Product Change Notice (PCN)

PCN Number: PCN-0451086R-01

Product(s) Affected: PJ-038-SMT and PJ-039-SMT

PJ-038-SMT

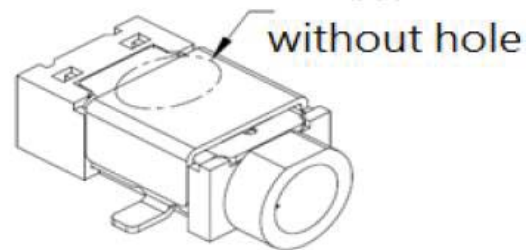
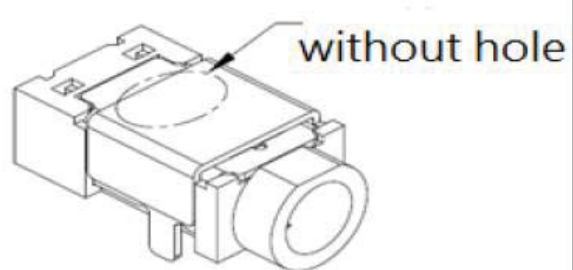
Reason(s) for Change: replacing existing mold maintain efficient production and quality.

Description of Change: appearance change as shown below:
